Port of Mostyn

Mostyn Energy Park Extension Project

Further Information in Support of Marine Licence Application
CML2283

August 2023

Figure 1. Surveyed bed elevation change across Mostyn Deep (incl. IS102 disposal site) between July 2009 (baseline) and June 2023

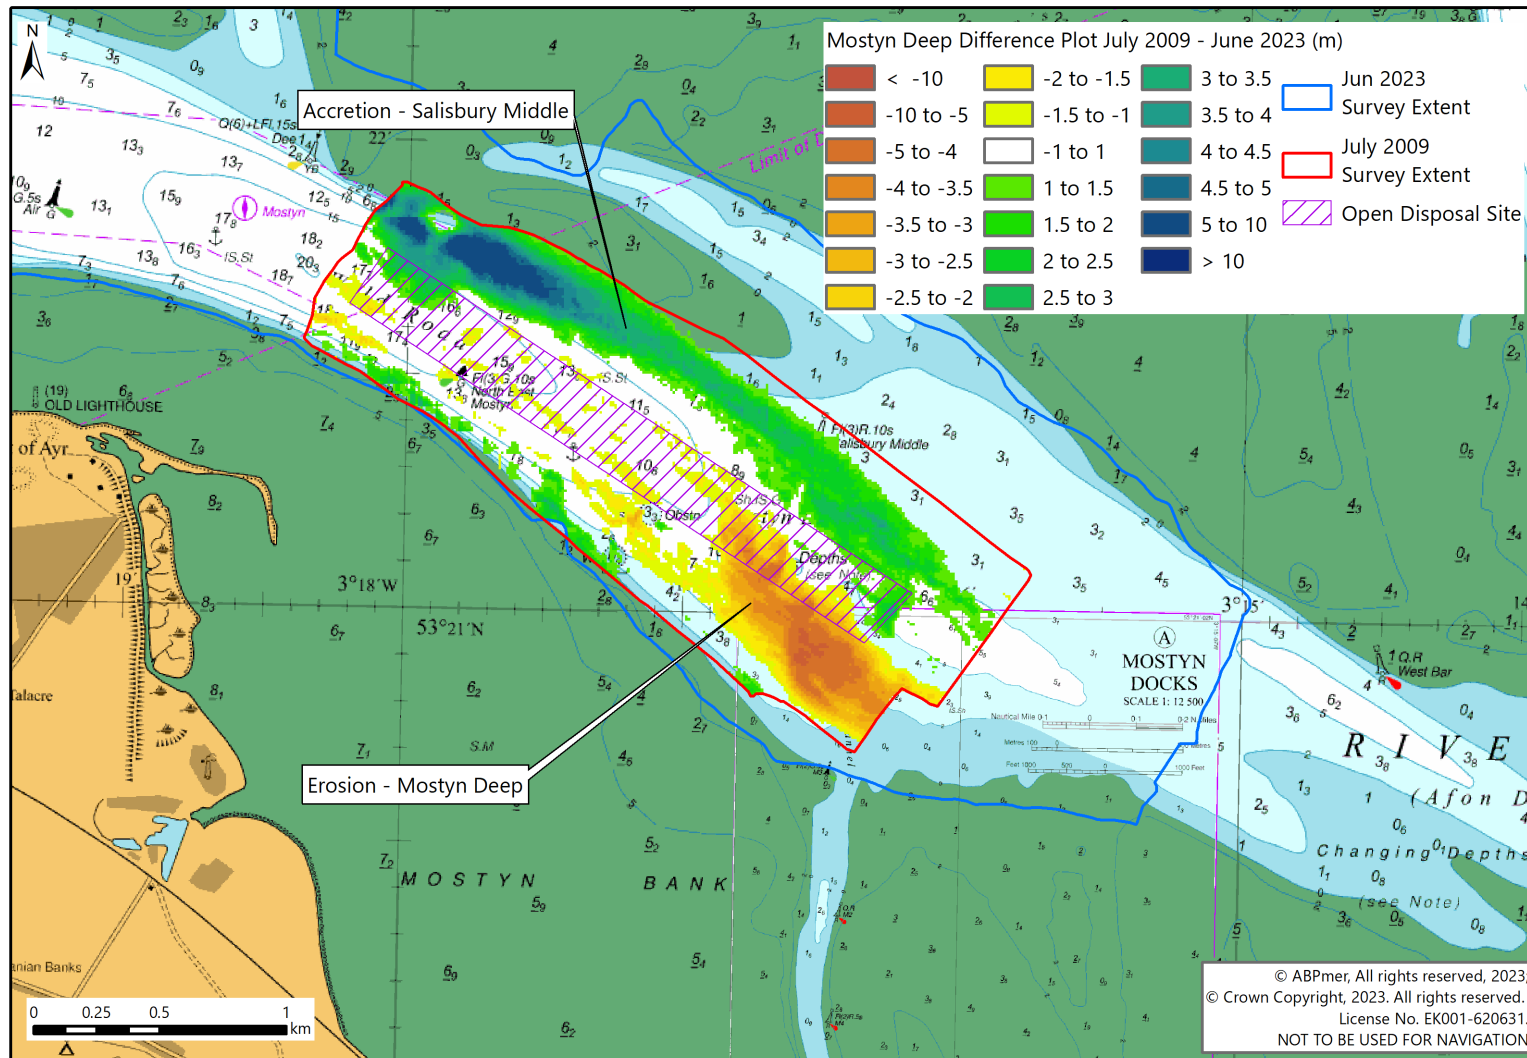
"Further assessment and evidence is required in order to provide confidence that Mostyn Deep disposal site is able to accept the volumes of material proposed, and that the potential impacts of disposal of this quantity of material over the time period proposed has been properly assessed. This concern has been raised by both Statutory Nature Conservation Bodies (SNCB): NRW Advisory (NRW A) and Natural England (NE). Further detail is provided below.

We request that you provide disposal returns for the Mostyn Deep disposal site and any other evidence, in order to support the statement made in section 6.7.2 of the ES the effect of the deposition of capital dredge arisings on the seabed bathymetry will be similar to that which already occurs as a result of ongoing maintenance dredging and disposal. Based on disposal return held by the Marine Licensing Team It is considered that the disposal volumes proposed exceed the volumes that have been deposited at the Mostyn Deep site in recent years."

Historic dredge records (see Table 3) and ongoing annual monitoring of the site (see Figure 1 and discussed further below) indicate that all material that has previously been deposited at the IS102 (Mostyn Deep) disposal site (under current and previous licences) has been dispersed. This is true under a range of annual disposal volumes from relatively little to upwards of 350,000 m³ (700,000 tonnes, as in 2010; Table 3). Continued monitoring of the disposal site (as is presently undertaken) would continue to provide a valuable oversight of the operations and allow for an early warning intervention should the disposal site show evidence of a general accretionary trend.

Analysis of the latest Mostyn Deep bathymetric survey (as reported in the June 2023 Annual Monitoring Progress Note; ABPmer, 2023 (included as Appendix E)), indicates very little variation in bed elevation between the 2009 (baseline) survey and the latest repeat survey from June 2023 (as shown in Figure 1). In fact, volumetric analysis of the differences between the two surveyed datasets indicates that the volume of bed material within the IS102 (Mostyn Deep) disposal site has actually reduced by around 340,000 m³ in the 14-year period between surveys. That is despite a total of over 1.2 million m³ (2.4 million tonnes) of material (in total) being deposited there, under the various maintenance dredging licences, over the same period (see summary information provided in Table 3).

Figure 3. Predicted excess SSC (top) and sedimentation (bottom) in relation to local and regional cockle bed features

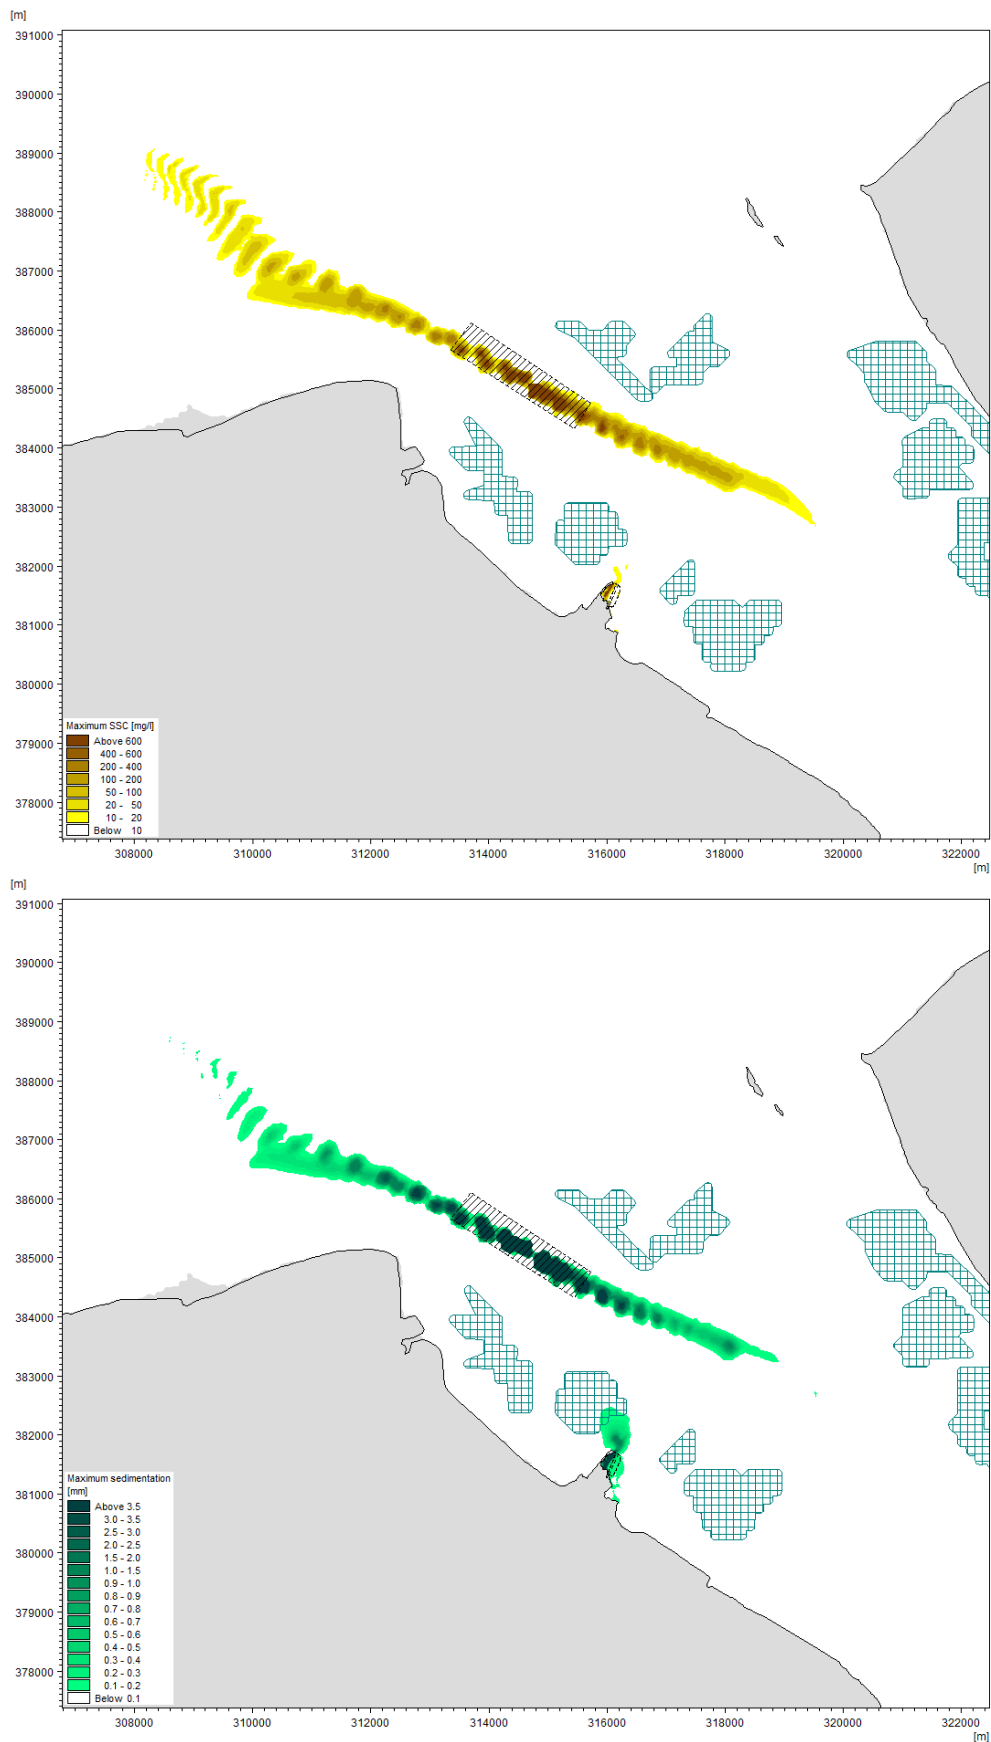
"We second Jo Ibrahim's comments regarding gaps in the sediment dispersal assessments, which should go further to show where dredged material moves to and settles in receiving receptors (e.g., cockle beds and navigable channel). In addition to Jo Ibrahim's comments, we recommend that supplementary sediment dispersal assessments includes potential indirect impacts on the navigable channel upstream of the development to Connah's Quay, Flintshire."

The map outputs from the modelling provided in ES Figure 6.8 show the maximum extent of excess SSC and associated bed sedimentation arising from continuous dredge/disposal over an 8-day period, whilst Figure 6.9 describes the temporal signal at a number of locations across the study area. The modelling shows that subsequent disposal events do not interact with each; consequently, the impacts in this figure can be considered as the predicted change in SSC and sedimentation for the duration of the dredging works (noting – as above – that the Port can accomplish the implementation of MEPE whilst working within the disposal limits currently approved within the existing DML1542 licence).

Furthermore, the map plots show negligible impact (to SSC or sedimentation) across the existing cockle beds or within the navigation channels (including upstream, towards Connah's Quay).

To provide further illustration of the predicted extent of impacts (in relation to the identified receptors, Figure 3 shows the modelled increase in SSC and sedimentation, as a result of dredging and disposal activity, in relation to the mapped cockle beds.

Figure 5. Habitats within MEPE reclamation that are not covered by existing permissions

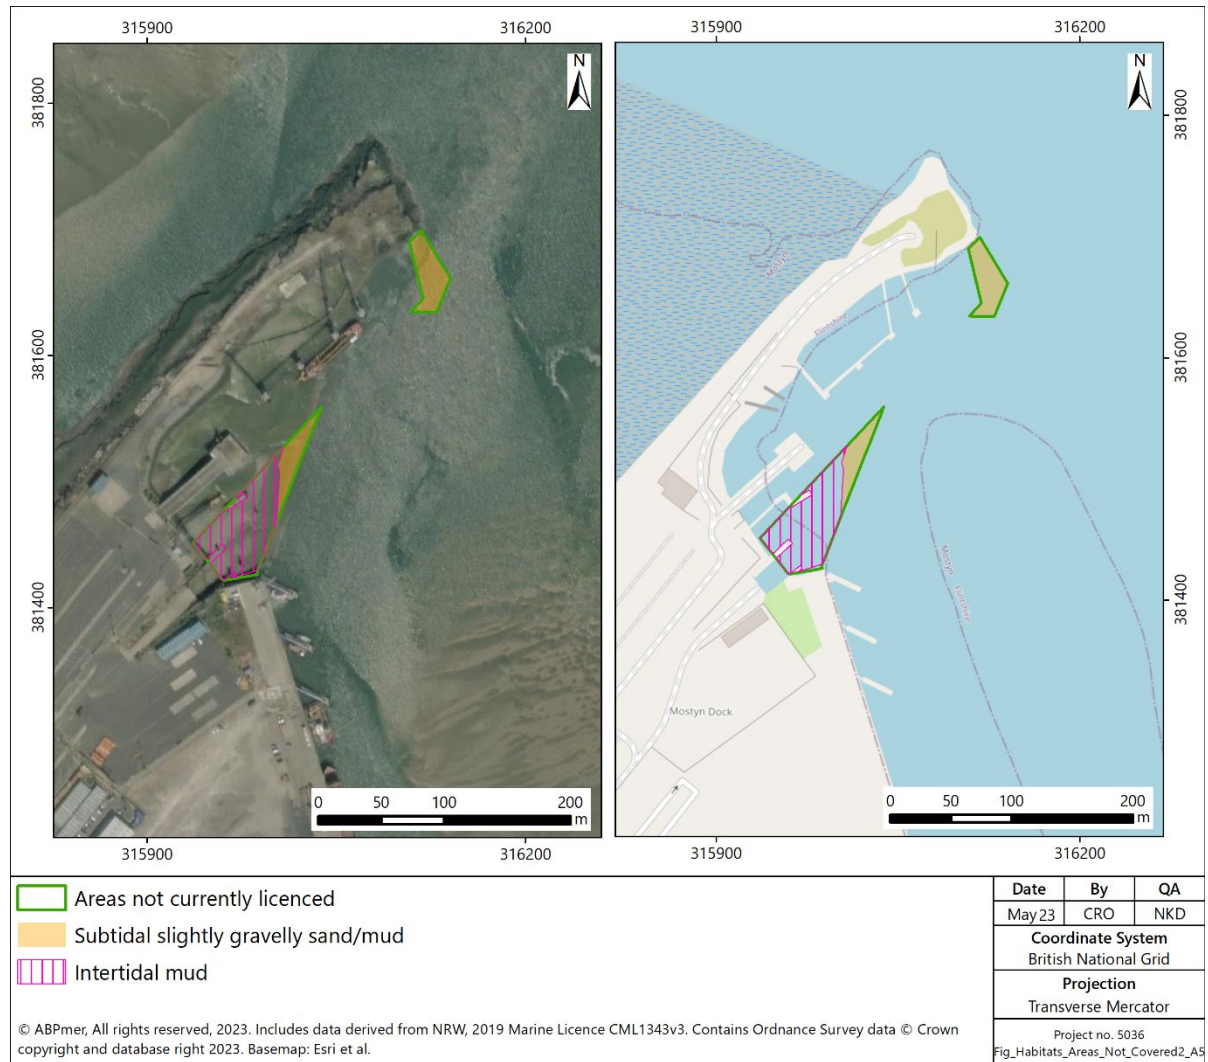
"With respect to the intertidal mudflat and sandflat habitat, the applicant has assessed this as negligible magnitude. We disagree with this assessment. The impact is long-term, non-reversible and over a large scale (2.57 ha). We therefore advise this should be assessed as Large magnitude of change. The probability of occurrence is high, thus giving a High exposure to change result. The importance of this habitat has been presented as moderate due to the poor quality of the feature. We disagree with this assessment. Whilst the number of species and abundance levels recorded in the samples are lower than those that have been recorded in other areas, the feature is still a qualifying Annex I feature of the Dee Estuary SAC and has not been subject to continuous dredging as other areas discussed in more detail below. We therefore advise the importance of this habitat should be presented as High. Based on the standard assessment matrix, resultant effect is major adverse with regards to the intertidal mudflat habitat. We note the applicant is proposing to scrape back rubble from the toe of the rubble along the western side of the dock estate to expose mudflat habitat on the Mostyn Bank. This could be used as mitigation for the major adverse effect on the intertidal mudflat habitat. However further information is required on the exact extent that this area provides compared to the 2.57 ha of intertidal mudflat and sandflat loss?"

The areas covered by existing permissions overlap the majority of the intertidal mud habitat (2.24 ha) under the footprint of the proposed MEPE reclamation. The remaining area of intertidal mud habitat (0.33 ha) under the footprint of the proposed MEPE reclamation that is not covered by either DML2001 or CML1343v3 is shown on Figure 5.

Figure 7. Location of ecological monitoring stations and cockle harvesting beds

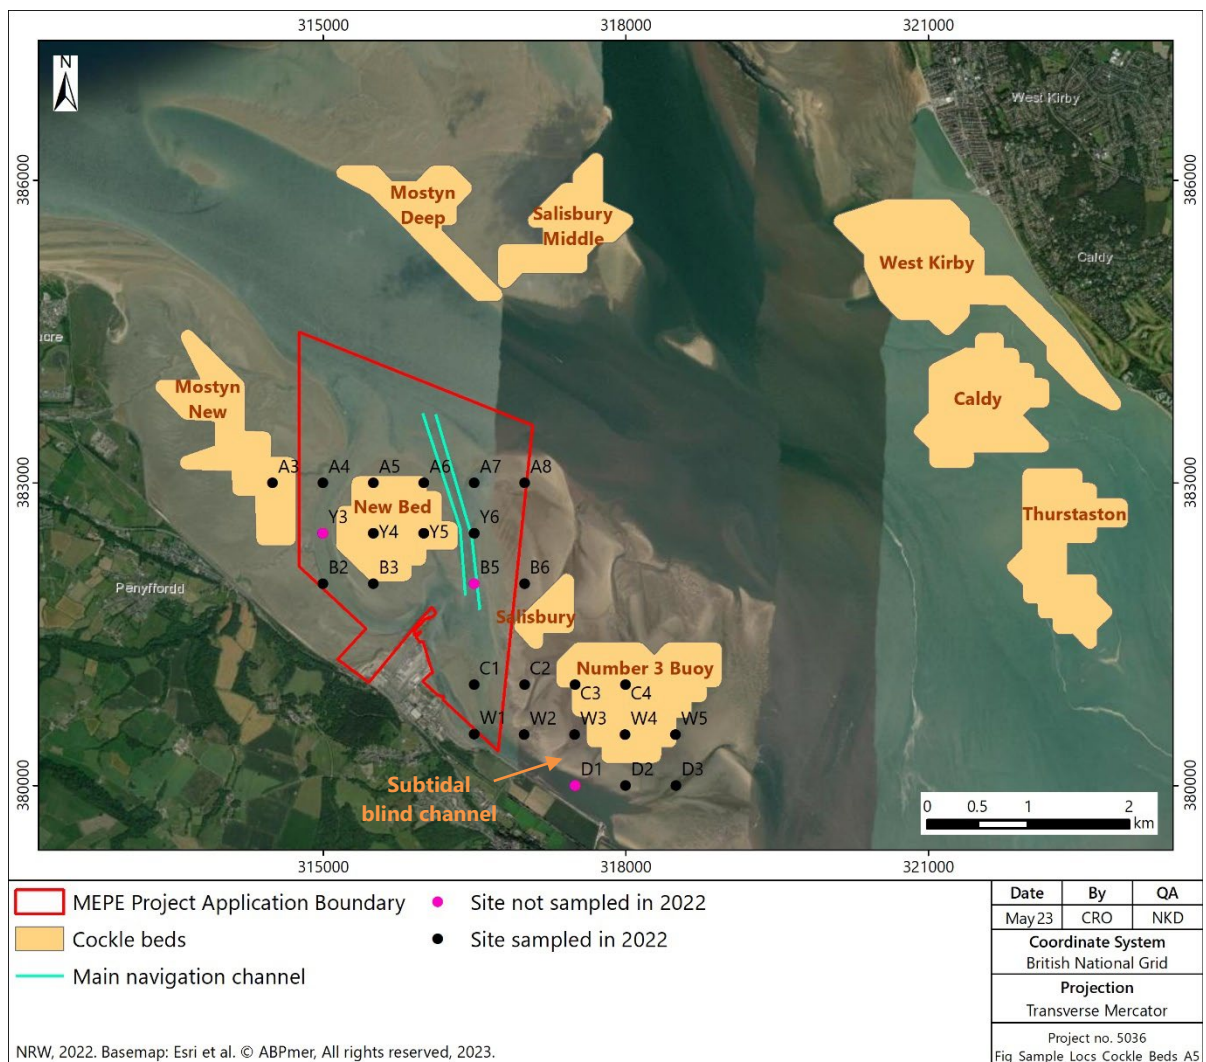
"We agree with the assessment that the potential impact of deposition from capital dredging of the berth pocket on benthic features is insignificant. Increased sedimentation above 10 mm is predicted within around 500 m, mainly across the proposed reclamation area, with sedimentation reducing to 1-2 mm off the end of the breakwater. The predicted sedimentation is below the pressure benchmark for the habitats immediately adjacent to the works. However, it is unclear whether the plume will reach the cockle beds. Chapter 6, Figure 6.8 shows the maximum sedimentation plume extending north of the breakwater. How far is the New bed cockle bed from the plume? It would be useful to overlay Figure 6.8 (in Chapter 6) with the known cockle beds to understand the potential interactions. If the plume extends to the cockle beds, any potential impacts from sediment deposition should be assessed.

Peak sedimentation depths within the Mostyn Deep disposal site (IS102 disposal site) are predicted to be around 50-60 mm, reducing to around 4-6 mm within the plume at distances of approximately 1 km from the disposal site. However, it should also be noted due to the flow direction at this location, no sedimentation on adjacent intertidal areas (including cockle harvesting areas) is predicted (Figure 3).

- **The area around Stations B3:** An emerging shoal of deposited material on the eastern margins of the Mostyn Channel which is also broadly the same area as 'New Bed' cockle bed);

- The area around of C3, C4, W3 and W4: These areas are broadly in the same location as 'Number 3 Buoy' cockle bed; and
- Habitat to the west of B6: This area overlaps with the 'Salisbury' cockle bed.
